## Tbilisi Mall

### Stage 1, Inspection Report

**Prepared For: Rakeen Uptown Development**

**Document No.: M8722 – RPT 001**

*Figure 1 - The Cladded Space Trusses and Lower Part of the CHS Cladding Grillage.*

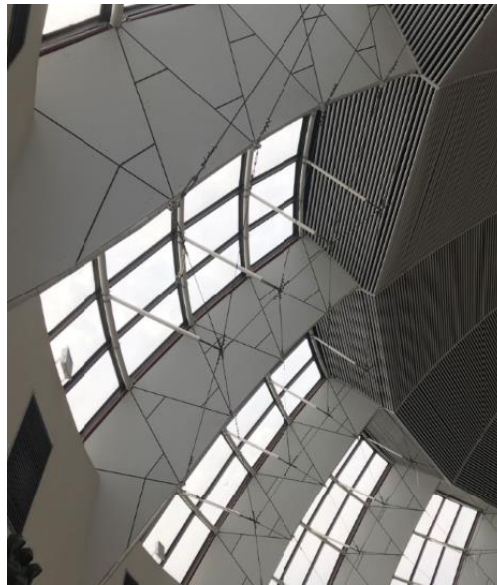
A network of steel bracing cables is providing for additional lateral support to the structure of the dome above the central atrium of the mall. See Figure 1 above.

RUD raised the concern that the steel bracing cables may be loose and locally corroded. The tightness of these cables was not able to be observed or measured during the inspection due to insufficient access, however RBG assesses that RUD's evaluation appears reasonable. It is however currently unknown whether the tension system is required from a strength perspective. Refer Figure 1.

A structural model of the main structural elements of the Central Atrium Dome is proposed to be created to properly understand the design requirements of the steel cables within the Dome. Once this is understood, the built structure can be evaluated, and any concerns and/ or recommendations can be communicated along with any recommended tests on the materials.

*Figure 3 - CHS with limited support.*

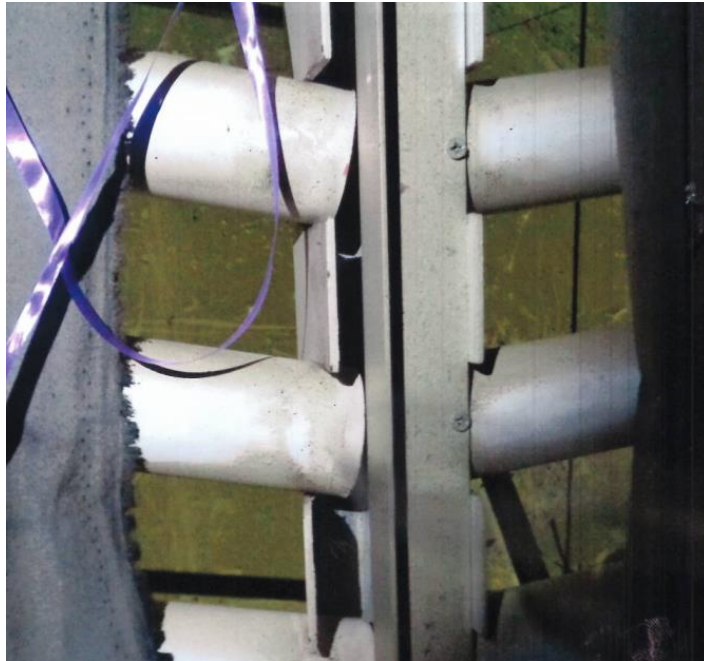
The pipes are supported at each end by steel or aluminum channels. There are numerous instances where the pipes are not connected to the rafters at these support locations and are free to be lifted out of place. Likewise, in many instances, very little bearing is observed.

Currently the individual pipes can potentially move and become dislodged from their supports during any lateral action and could present a serious falling hazard. The witnessed support of the secondary CHS Cladding Grillage does not appear sufficient. Refer Figure 2 and Figure 3.

A risk assessment and solution optioneering are to be done for the pipes that are not securely fixed in place. Following this optioneering phase the most viable option shall be developed and detailed for implementation, if the currently installed cladding solution is found to be inadequate, the most viable option can be implemented.

*Figure 6 - Identified Deterioration*

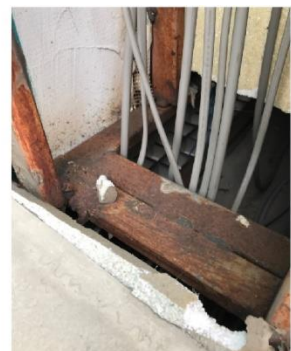
Instances of deterioration in the cladding that were observed include:

- Corrosion of secondary steel framing members.
- Cracks appearing through the paint/ stucco finish of the cladding.
- Peeling/ bubbling/ delamination of paint.

1. The steel framing does not appear to have been sufficiently corrosion protected. Typically, aluminium framing is used for this kind of secondary façade-supporting structure, however if steel is selected the protective treatment needs to be selected carefully to ensure adequate durability resistance in both the framing and all connections.
2. The panels do not appear to have been fastened with any physical connection aside from the mastic/ silicone material.
3. The selection of the stucco boards does not seem durability-wise adequate to sustain a significant duration. This obviously depends on the Clients requirements for maintenance and aesthetics.

More investigation needs to go into identifying the best solution for the cladding. Due to the significant area, potential cost and the impact during the rectification works it is essential to identify the most appropriate solution to the façade rectification.

It is recommended that a consultant will formulate and propose a series of options for RUD to discuss with their contractor of choice and thereafter be implemented.

Figure 11 - Mall Overview

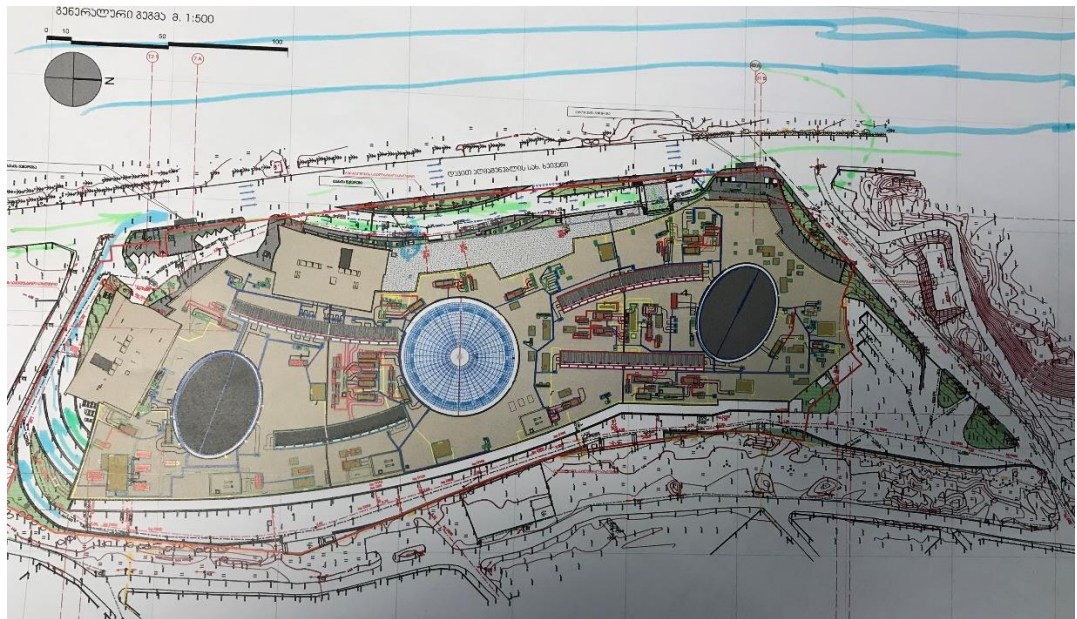
The main entrance is problematic as incoming traffic must cross over the outgoing traffic coming from the basement car park.

Crossing-over of traffic lanes is causing congestion issues, especially during busy periods.

- Reversing the traffic flow in the basement and constructing an additional fly-over ramp for the traffic in the opposite direction (to avoid the congestion from mall visitors exiting the mall and U-turning).
- Elevating the existing road for by-passing traffic.
- Elevating the entrance ramp to avoid the congestion.
- An alternative entry to the basement car park is another possible solution. The effects of removing any walls to enable an alternative entry to the basement car park and to identify any enabling and/or retrofitting works required will have to be investigated.

To achieve the most viable solution the traffic flow should be investigated by a traffic engineering consultant as mentioned above.

*Figure 13 - Sketches of the Proposed Modifications*

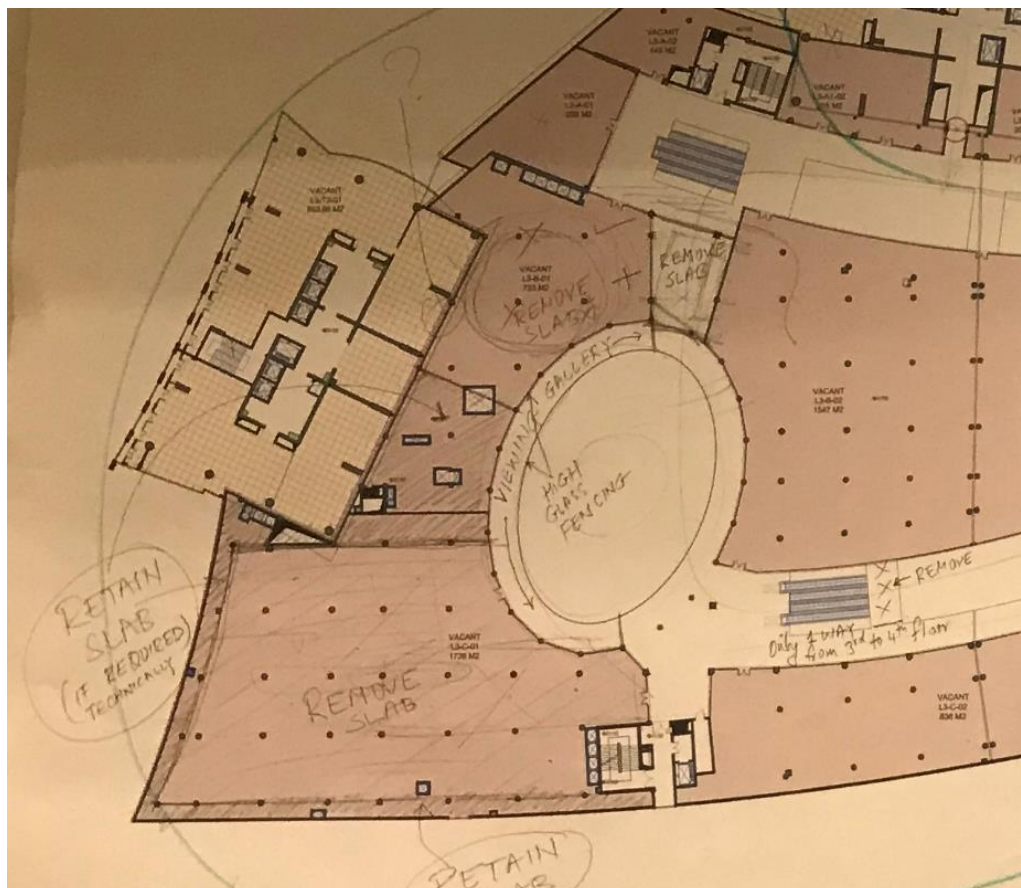
RUD is considering the removal of columns and areas of the slab to accommodate the newly proposed entertainment area on L3/ L4, refer Figure 13 for a sketch of the proposed modifications.

- Greater design forces will be applied due to increased loading from entertainment purposes (e.g. “extreme rides”). Loading will be 2 to 3 times more than the original design intent (approximately 12 to 15 kPa compared to approximately 5 kPa).

- Potentially greater design forces due to increased column tributary areas (as a result of increased slab spans caused by the removal of columns).
- Columns will be slenderer due to the double-story high columns.

- The roof span increases from the designed span of 8 m by 8 m to a significantly larger span, approaching 24 to 32 m.
- The roof carries localized heavy-duty MEP equipment which needs to be kept operational during the construction. This poses strict procedures for the construction methodology and erection sequence (CMES).

A structural model needs to be created to evaluate the existing structure in order to establish if the structure is acceptable and code compliant. Only once an understanding of the structure has been established can alterations such as removing slabs and columns be considered and assessed along with possible retrofitting solutions.
